25/0763/COND / Enterprise Autos / Discharge of Conditions Supplementary Letter (v2)

We have received a copy of a Decision Notice in response to a submission for Discharge of Conditions 3 and 7 (reference above) in relation to the remediation and proposed redevelopment of the Enterprise Autos site (the site), Newbridge Bypass, Crumlin, Newport. This notice refuses the discharge of these conditions and is supported by a consultation from National Resources Wales (NRW) and Caerphilly County Borough Council (Environmental Health Officer -EHO), in which provides commentary upon their concerns.

Figure 1. Site Plan showing approx locations of Petroleum Officer identified tanks (A, B and C), investigation locations and constraints (dotted in blue)

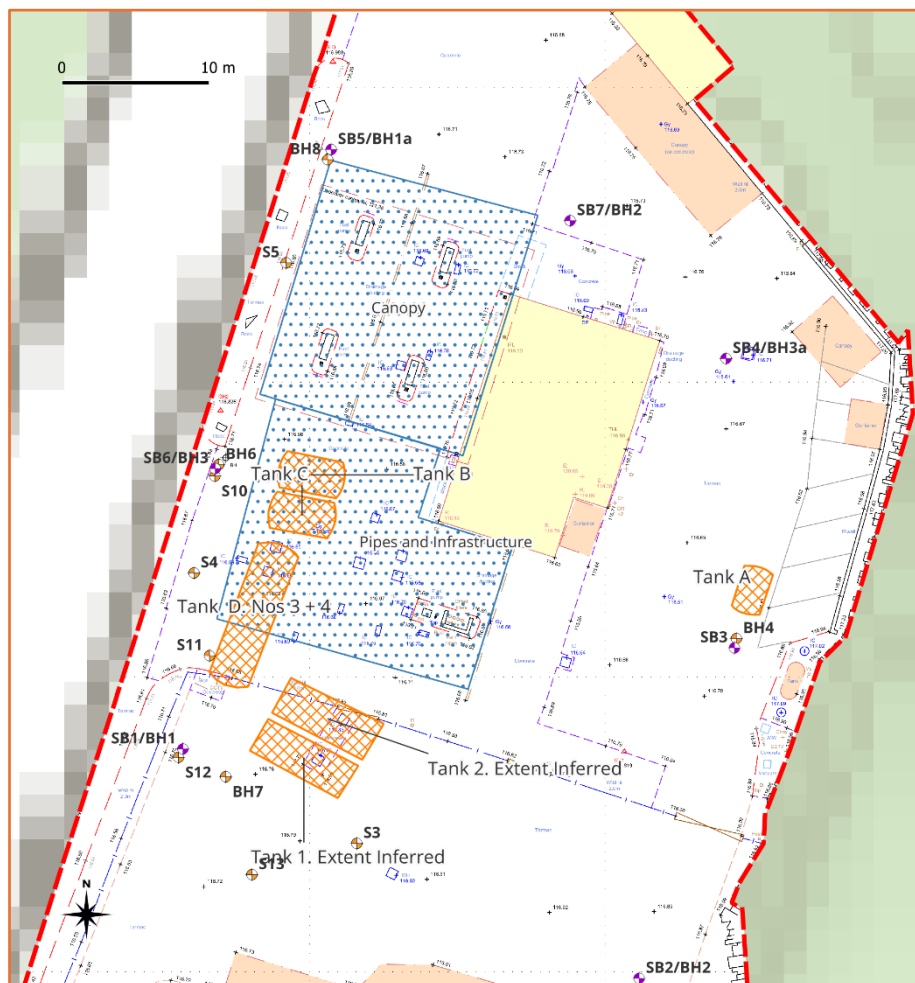
1.2. In addition to the current known infrastructure, the PO report has identified:

- A historical small above ground storage tank at the rear of the site (A)
- A further two small Underground Storage Tanks (USTs) (B and C) located in the same tank farm as Tank 3 (known to have failed) and Tank 4. These historical tanks are understood to have been decommissioned with a concrete fill. It is unknown whether they remain in situ.

Each of these features is shown on Figure 1, below, which georeferences the sketched locations against the existing investigation data. Please note that the PO records are not to scale and extents are inferred only.

- 2.4. Geo² consider that all identified sources have been suitably targeted by the investigation. The information provided by the Petroleum Officer does not merit any amendment to the conceptual site model as key features, where physically practicable with the site in its current form, have already been targeted by investigation points.
